**TRINITY CHRISTIAN ACADEMY
NEW PERFORMING ARTS BLDG.
BUILDING CONSTRUCTION PLANS
17001 ADDISON RD., ADDISON, TX 75001**

WATER & SEWER PLAN

C3.0

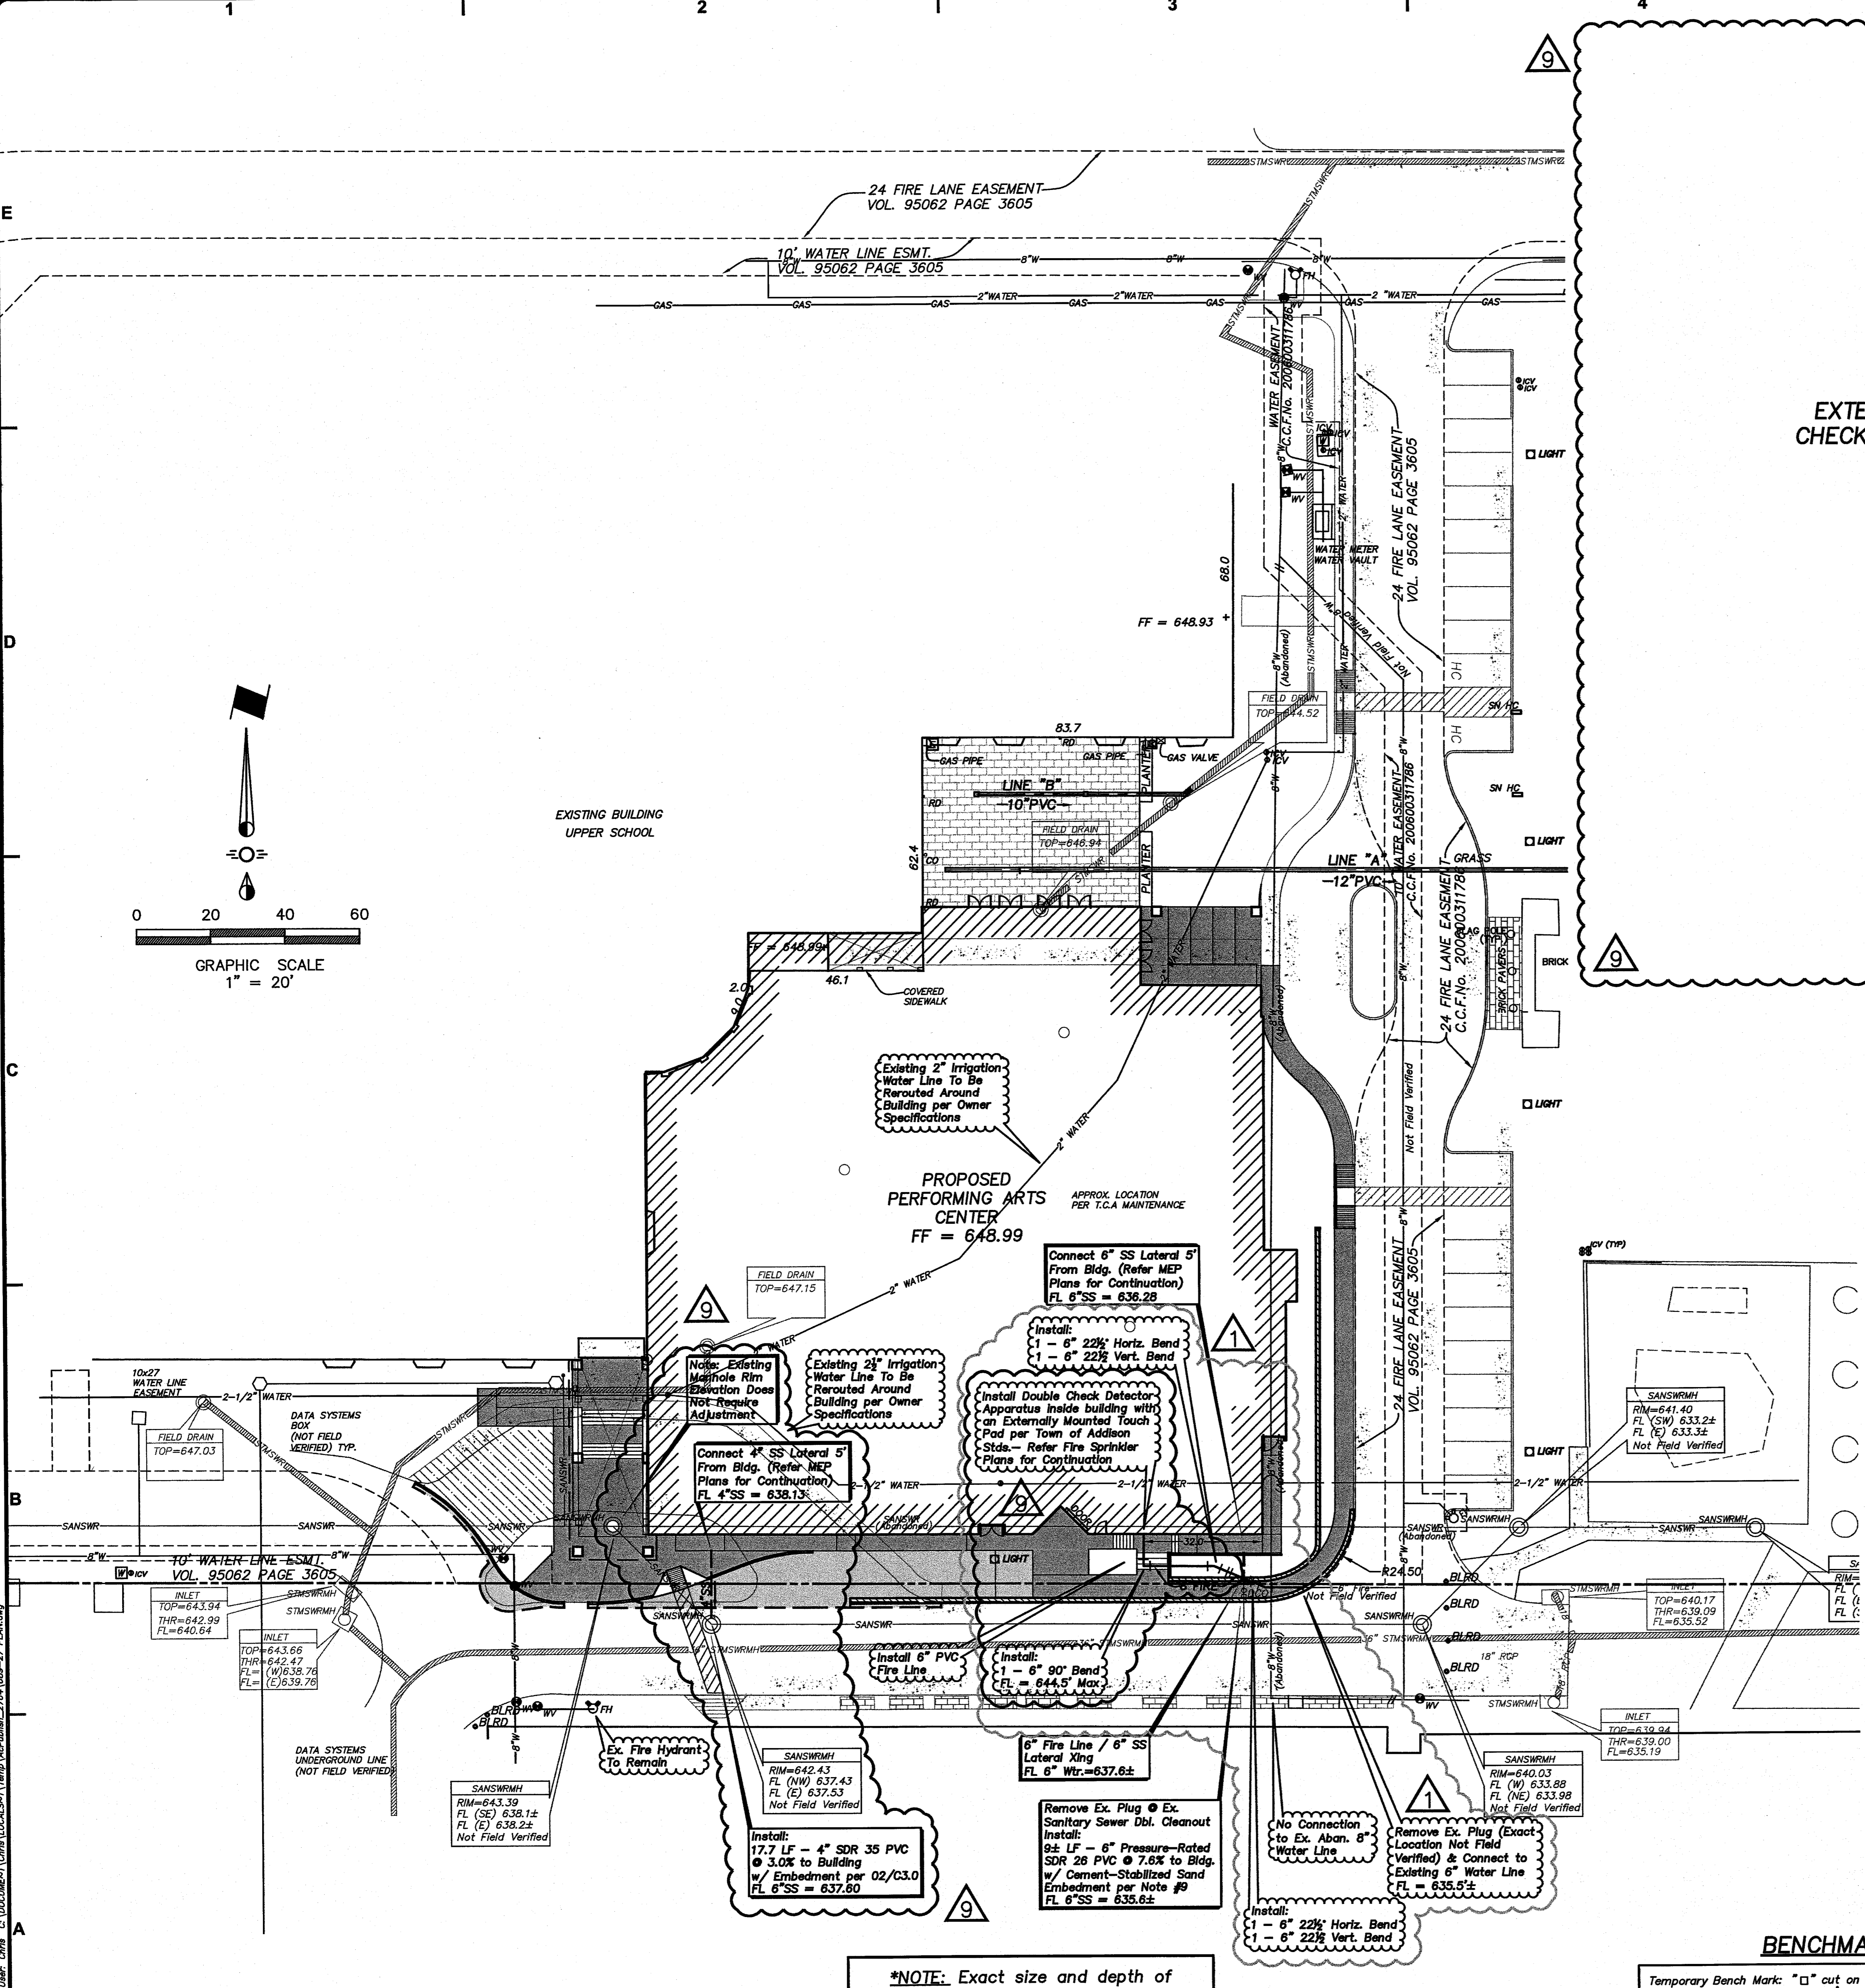
EXTERNAL DETECTOR CHECK & VAULT DETAIL DELETED

Original Issue Date	Rev	Date	Description
March 30, 2009	1	June 19, 2009	Issued for Construction
	1	May 18, 2009	Fire line revised; main revised; small school
	2	July 29, 2009	Detector check moved into building; fire main
